Subject: BWR Owners' Group Comments to Draft Regulatory Guide (DG-1111),  
"Atmospheric Relative Concentrations for Control Room Radiological  
Habitability Assessments at Nuclear Power Plants"

**BWROG Project Number 691**

BWROG CRH COMMITTEE  
UTILITY COMMENTS TO  
**DRAFT REGULATORY GUIDE 1111 (Atmospheric Relative Concentrations for CRH)**

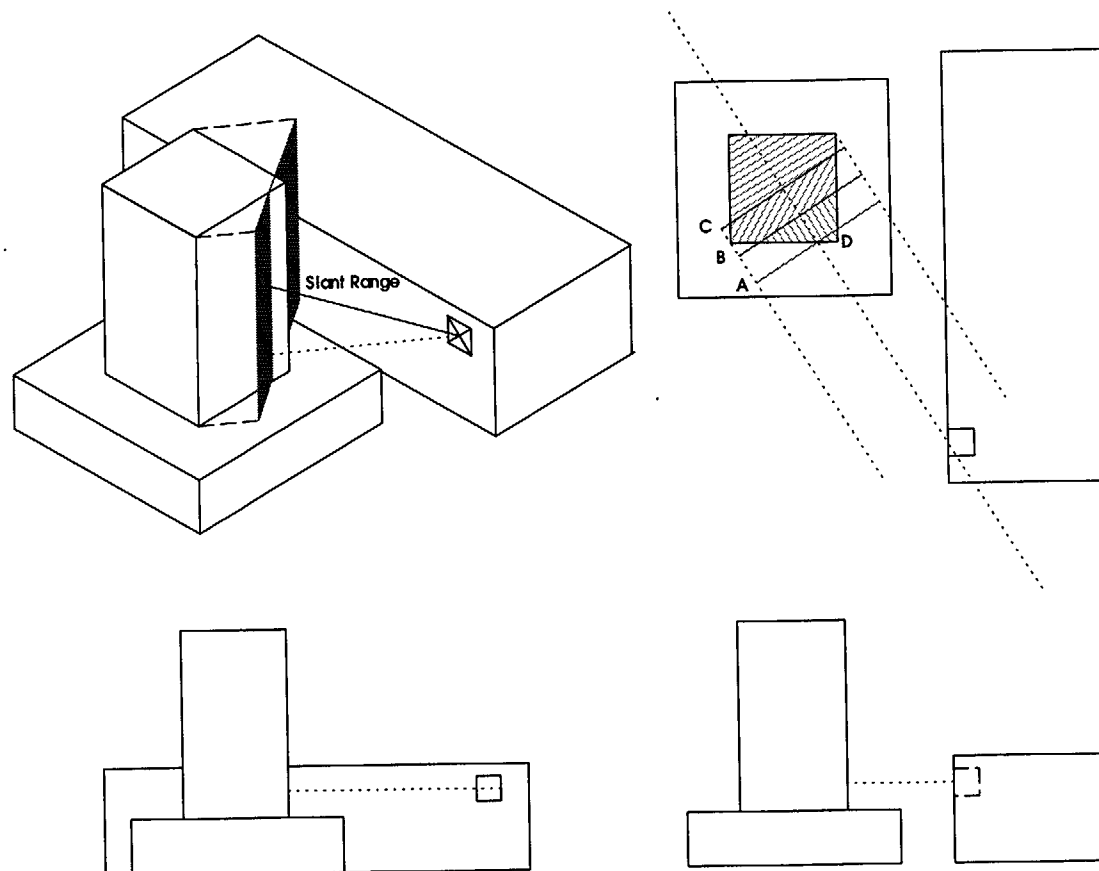
<b>DG-1111 REFERENCE</b>	<b>COMMENT</b>	<b>RECOMMENDED CHANGE</b>
Section C (Regulatory Position), Subsection 2.2.4.5	(See attached sketch) Use of the diffuse source option is permitted for releases from volumes with a homogeneous concentration of radiological source (2.2.4.1). The total release rate must be assumed (2.2.4.2). The RG restricts the selection of diffusion coefficients more than the values recommended in the NUREG (2.2.4.3). The shortest horizontal distance from the source-building surface along the line of sight to the source building centerline (Line A on the sketch) is used rather than a slant range to the geometric center of the effective diffuse source plane (2.2.4.5). Credit has not usually been allowed for holdup or retention in the release building (2.2.4.8), and decay during transport time is not credited by codes like RADTRAD. Based on these provisions, the guideline for calculating the source to receptor distance is probably more conservative than necessary.	<ol style="list-style-type: none"> <li>1. Base the source to receptor distance on the source building centerline (Line C on the sketch) or some point between the building surface and the centerline. (e.g., Line B on the sketch is approximately half the distance between the closest point along the line from the intake to the source building center and the source building centerline)</li> <li>2. Allow the source to receptor distance to be a slant range.</li> </ol>
